July 17, 1985
PY-CEI/NRR-0283 L

Perry Nuclear Power Plant
Docket Nos. 50-440; 50-441
Response to Comments on
the Perry Unit 1 Offsite
Dose Calculation Manual (ODCM)

Attached is our response to your comments transmitted May 20, 1985 on the Perry Unit 1 Offsite Dose Calculation Manual. We have also included a proposed change to ODCM Section 2.3.2 in Attachment 2 for your review. The ODCM will be revised to reflect the changes made in these attachments and transmitted to the NRC by August 15, 1985.

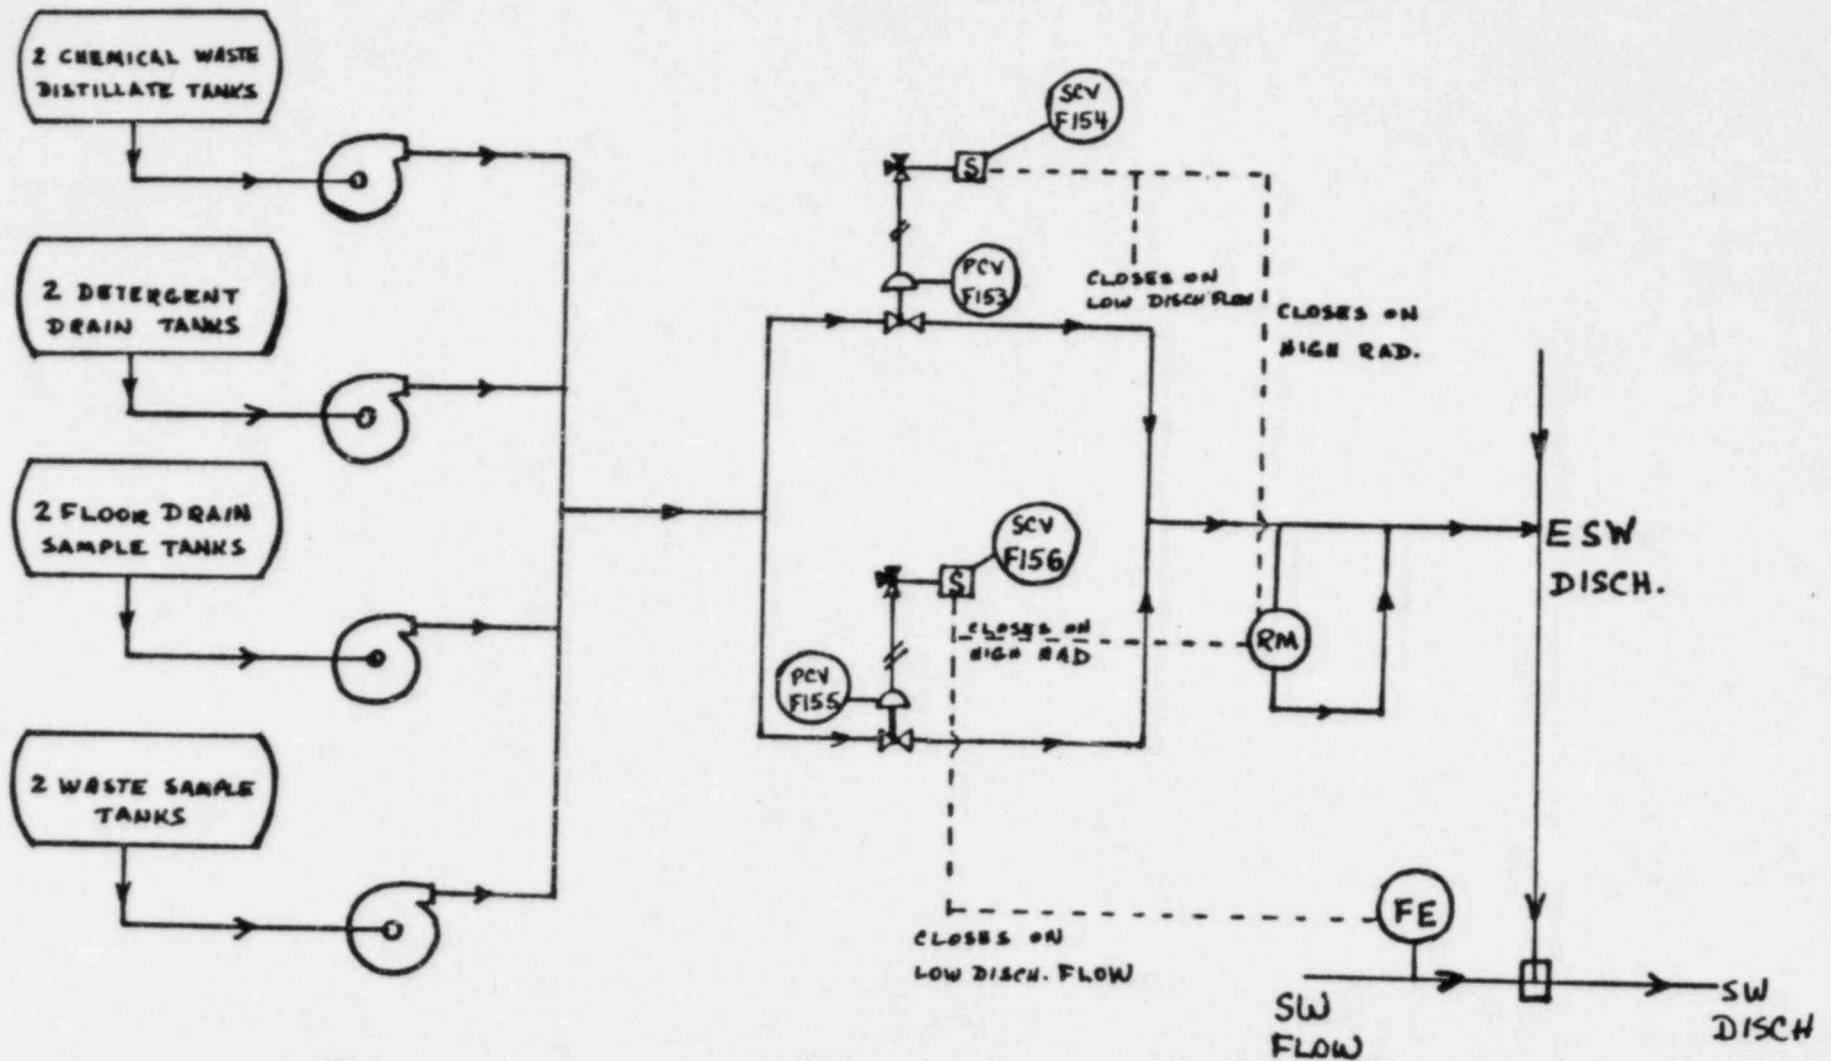
Provide in Section 2 a flow diagram of the liquid radioactive waste treatment systems, including the discharge point and the Radwaste Discharge Radiation Monitor. This should be a simple diagram with as little extraneous detail as possible.

From pg. 11.2-20 of the FSAR it would appear that mdf=10,000 rather than 30,000 gpm.

A simplified flow diagram (Attachment 1-1) showing the pertinent aspects of discharge is attached and will be included in the revised ODCM. Detailed drawings of the liquid radioactive waste treatment systems are provided in FSAR Figure 11.2-11, sheets 1 through 15.

The minimum dilution flow (mdf) for liquid releases is 30,000 gpm. A low dilution water flow rate of 30,000 gpm actuates solenoid valves G50F154 and F156 which close the main process isolation valves G50F153 and F155 as shown in Attachment 1-1 of this attachment (Response 1 above), thus terminating the release.

PNPP ENVIRONMENTAL
RADIOLOGICAL MONITORING PROGRAM
SAMPLING LOCATIONS WITHIN 5 MILES OF SITE

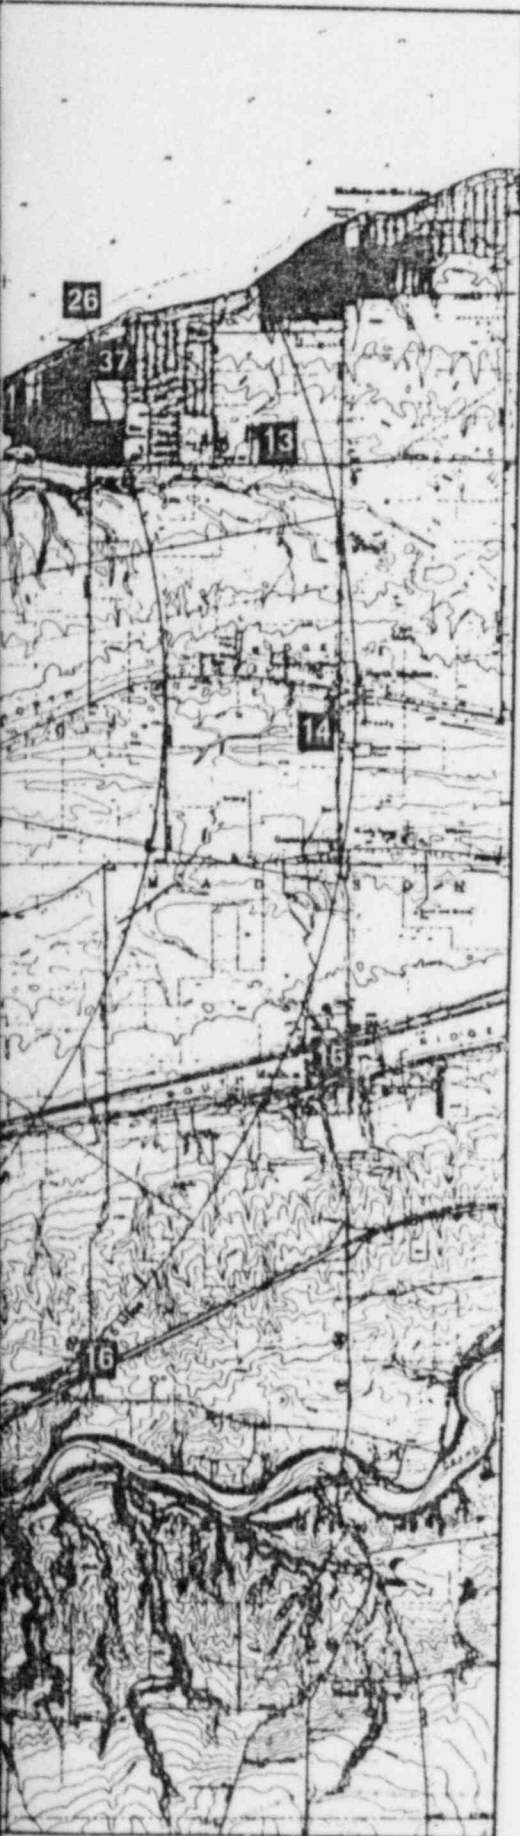
The ODCM should contain sufficient information to enable calculation of doses for the necessary pathways. For use in Section 2.3.1, additional site specific information should be provided. Provide a listing of the points of exposure, the points of withdrawal of drinking water and the points of harvest of aquatic food, identifying the location and the dilution factor M_p for each. Provide in the ODCM a map showing the locations of the closer drinking water intakes.

Drinking water sampling (Table 5.1-1) should also include the Lake County supply for which the intake is located about 1.5 miles west of PNPP.

A map showing the radiological environmental monitoring program sampling locations (including drinking water intakes) within 5 miles will be incorporated into the ODCM (Attachment 1-5). There are two drinking water intakes within 5 miles of the site: (1) Location 36 - Painesville Water Supply Intake - 3.9 mi. and (2) Location 37 - Ohio Water Service Co. Pump Station - 4.1 mi.

The Lake County drinking water supply is located 3.9 miles from the Perry site at the former location of the Industrial Rayon Corporation intake and is identified as location 36 on the Radiological Environmental Monitoring Program sampling location map (Attachment 1-5). The Final Environmental Statement stated that this intake would be in service soon and that it is 1.5 miles southwest of the Perry site. It is in service now; however, the intake is 3.9 miles from the PNPP site vs. 1.5 miles.

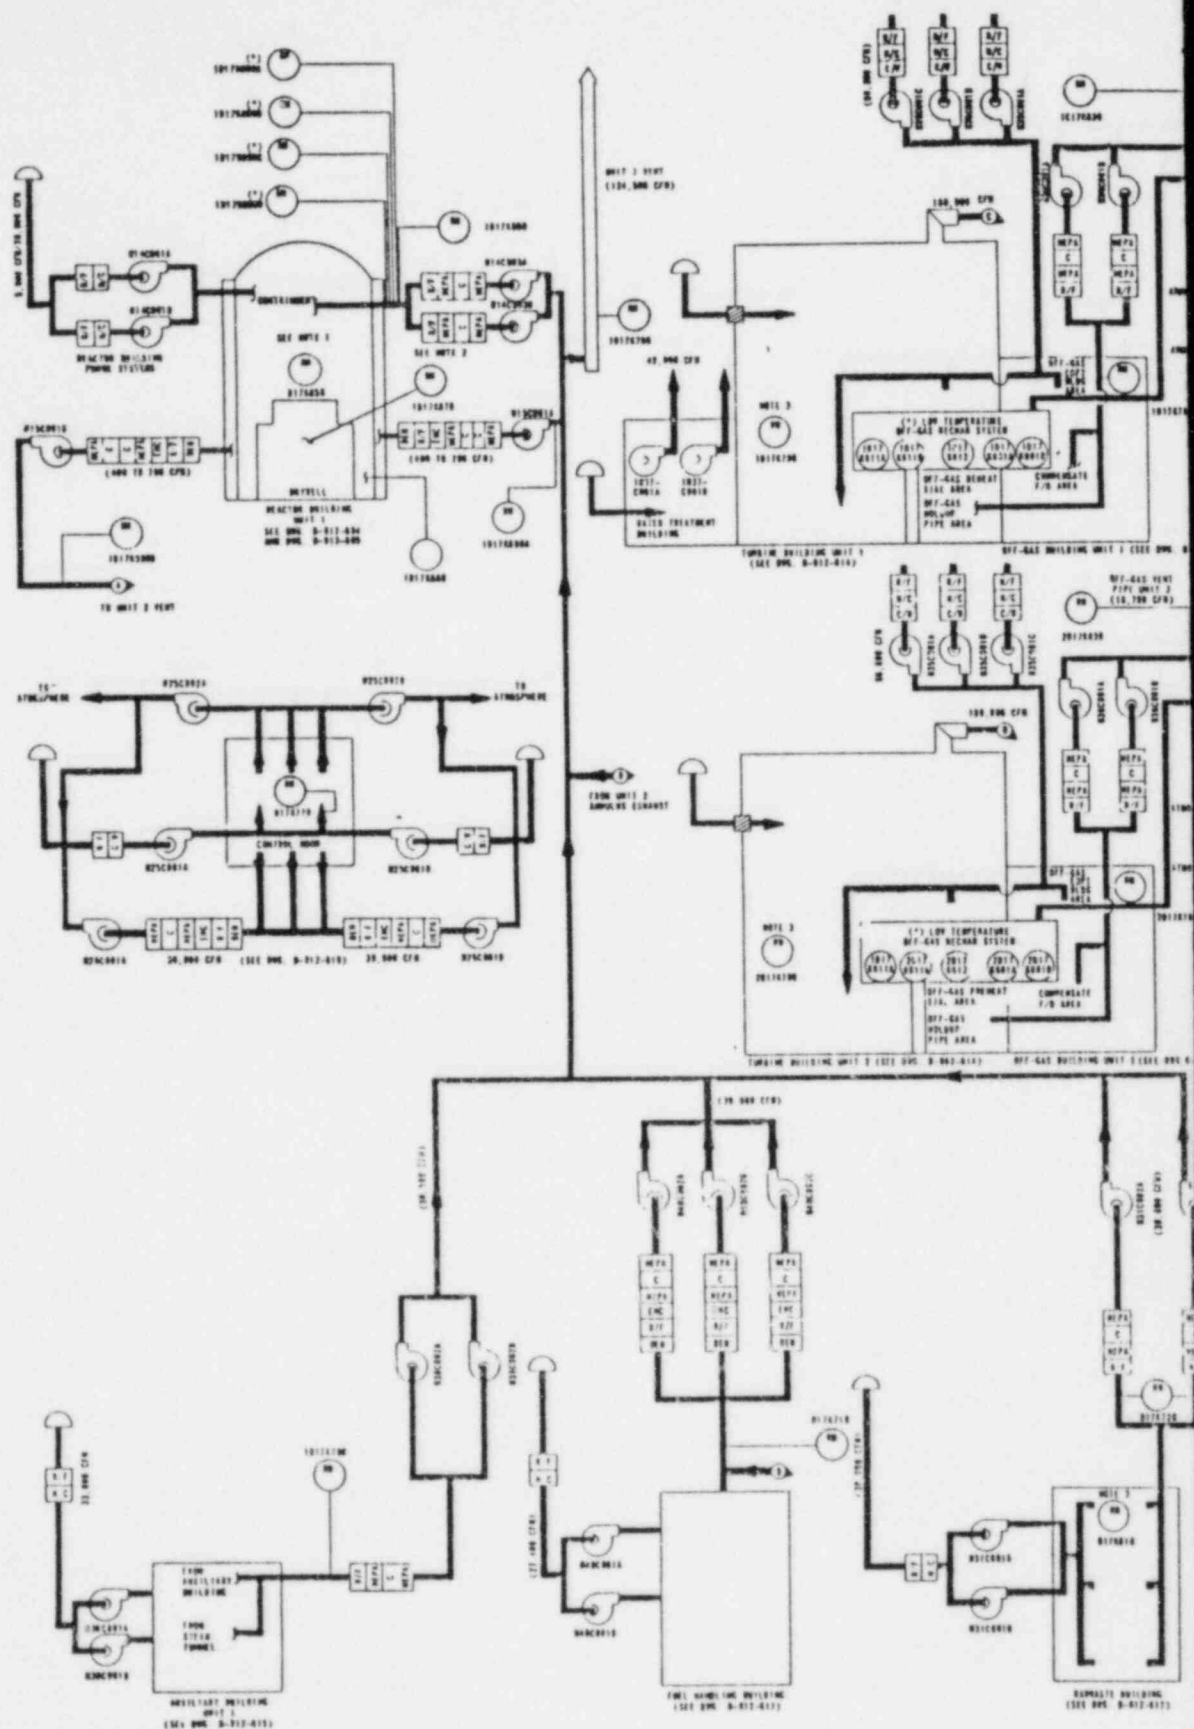
In Section 3.2, provide a map of the site showing clearly the Site Boundary and the boundary to the Unrestricted Area. Show the compass directions and a scale of distance, such as provided in Figure 5.1-2.

A map clearly showing the Site Boundary and the Unrestricted Area as well as a scale of distance and a North arrow is provided as Attachment 1-7. It will be incorporated into the ODCM.

GASEOUS RADWASTE SYSTEM FLOW DIAGRAM

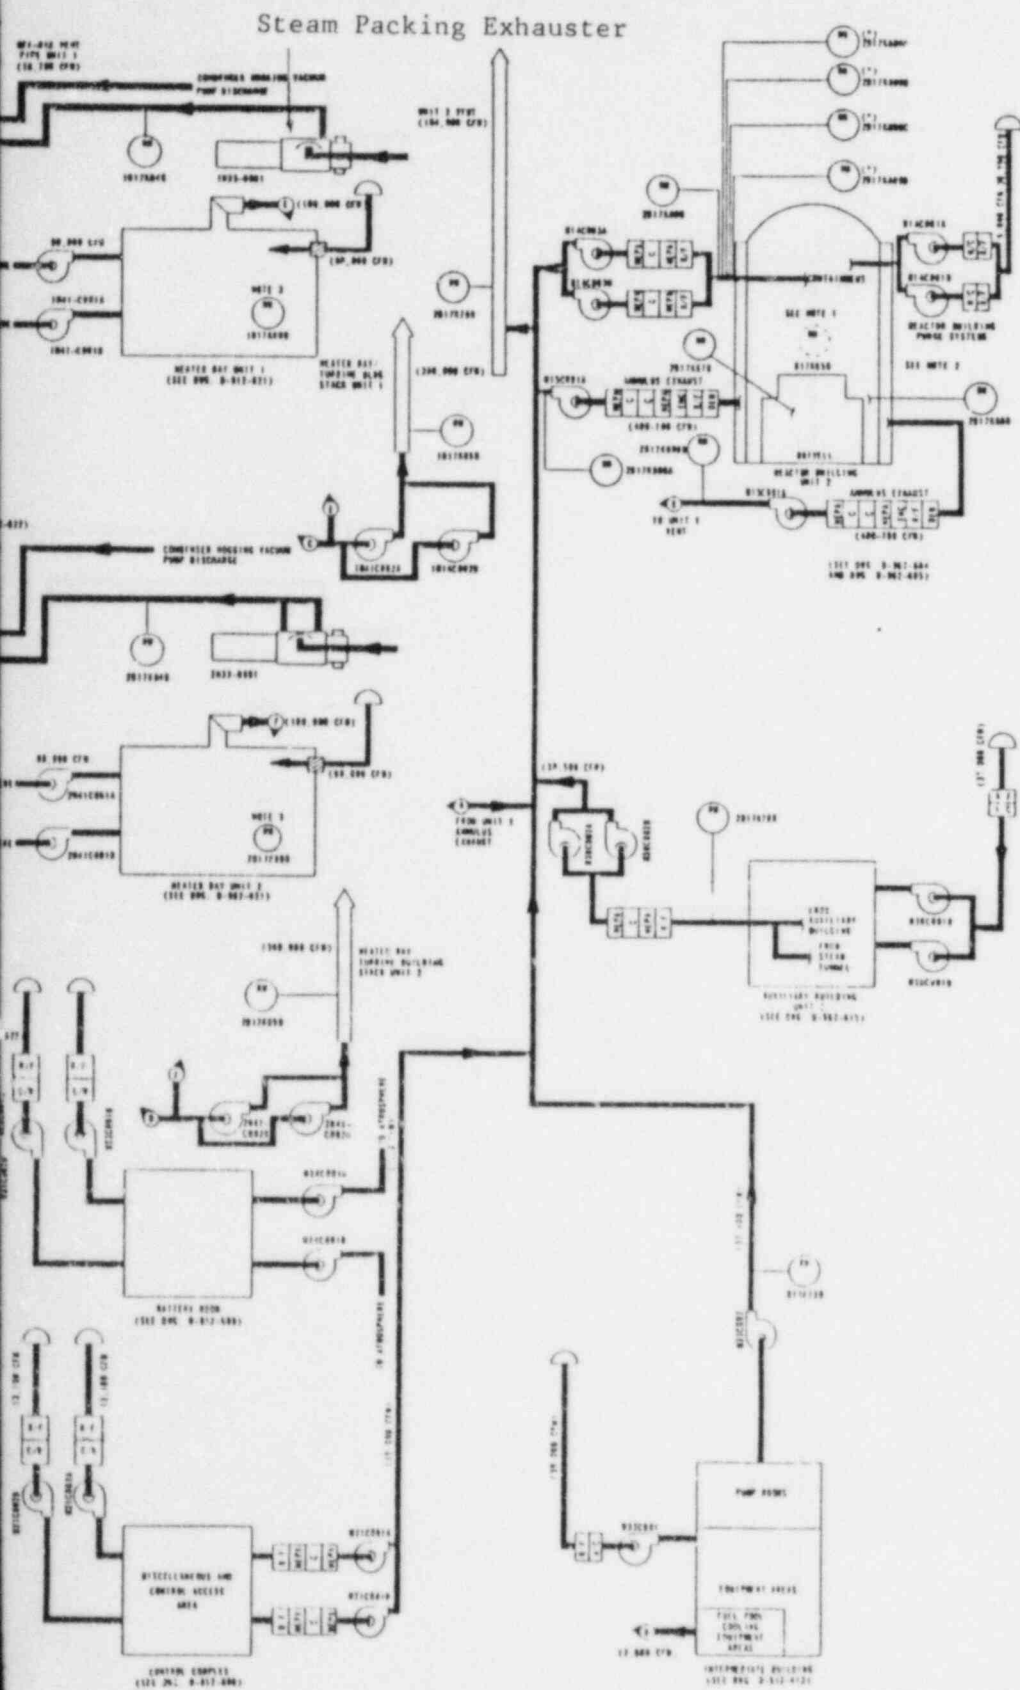
With Section 3.0 Gaseous Effluents, provide flow diagrams of gaseous radioactive waste treatment systems leading to each of the four environmental release points. Show the location of each radioactivity release monitor for gaseous effluents. Provide the location and a brief description of each release vent point, including whether the vent is equipped with a deflector.

The steam packing exhauster should be added to this section as a potential release point.

The gaseous radwaste system flow diagram is provided as Attachment 1-6. This diagram will be incorporated into the ODCM.

The steam packing exhauster vents through the Offgas Vent Pipe, Unit 1 as indicated in Attachment 1-6, and is therefore not a potential release point.
